MIL-PRF-19500/382C
AMENDMENT 1
25 September 2000

SEMICONDUCTOR DEVICE, TRANSISTOR, PNP, SILICON, LOW-POWER
TYPE 2N2944A, 2N2945A, AND 2N2946A
JAN, JANTX, JANTXV, AND JANS

This amendment forms a part of MIL-PRF-19500/382C, dated 28 July 1999 and is approved for use by all Departments and Agencies of the Department of Defense.

FIGURE 4. Pulse response test circuit.

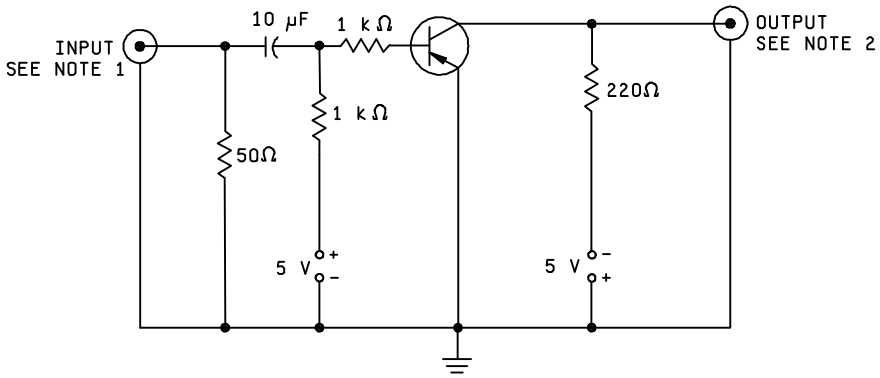
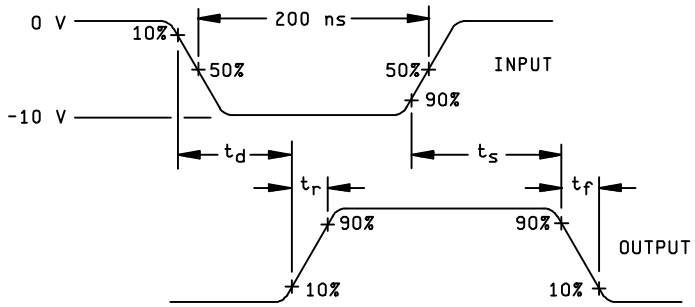
Figure 4 Delete and substitute:
